INVITATION TO BID 2026-01
CITY OF PARKER
2025 ROADWAY RESURFACING PROJECT

**ADDENDUM NO. 4
NOTICE TO BIDDERS**

Issued September 29, 2026

Sheet No.
C2.15

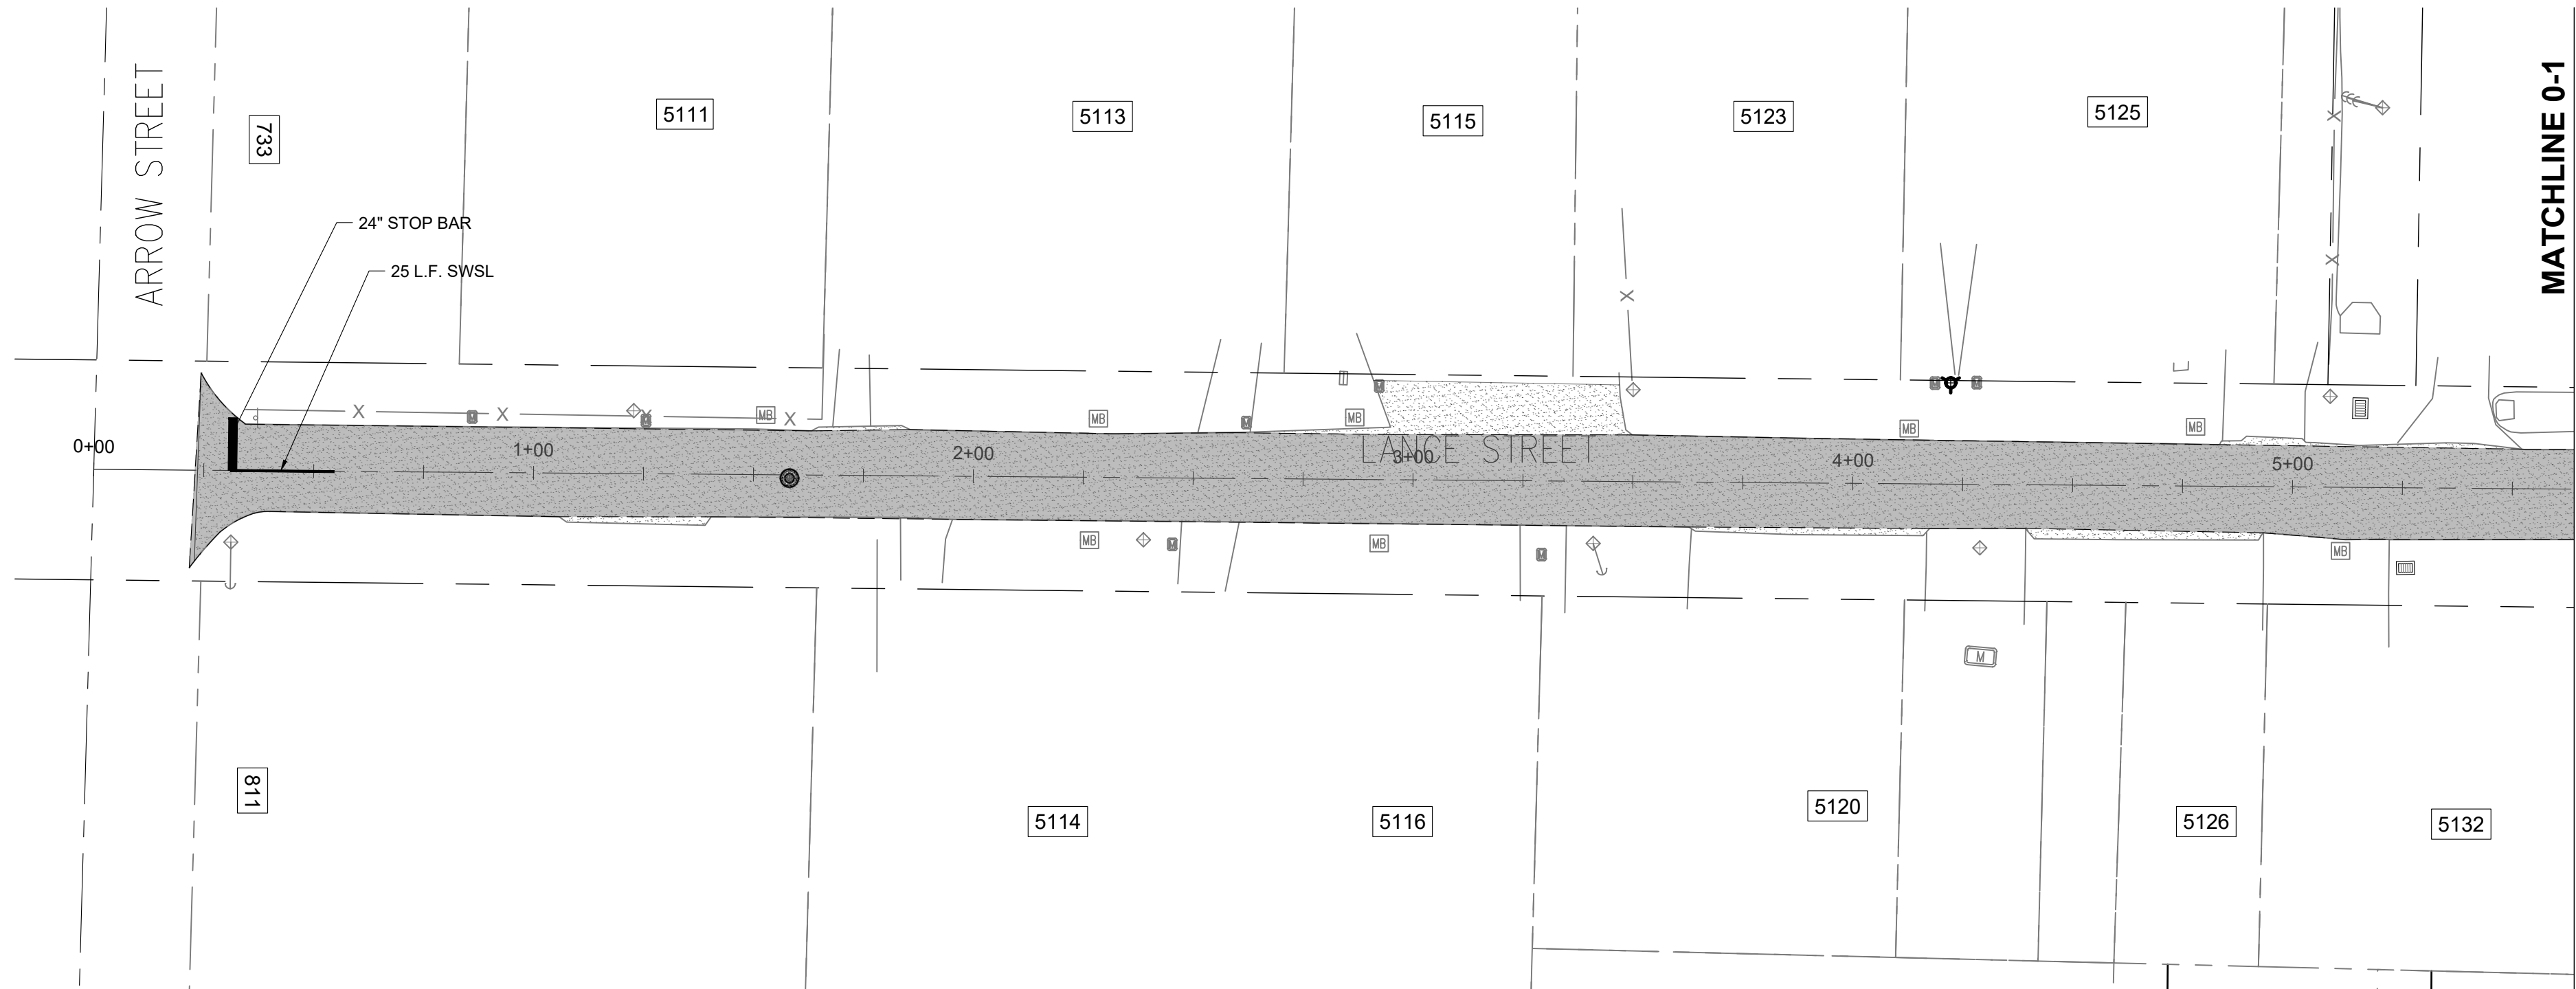
- i. Sheets C2.11 through C2.15– N. 9th Street Sections: Sections have been modified within each sheet and a note has been **ADDED** to each sheet which states, **“CONTRACTOR TO ADD COMPACTED FILL ALONG THE EDGE OF THE ROADWAY IF THE DROPOFF IS MORE THAN 1.0” AND SHALL BE PLACED AT A SLOPE OF 1:4 IN ACCORDANCE WITH 2026 OR CURRENT EDITION OF FDOT STANDARD INDEX 570-010.”**
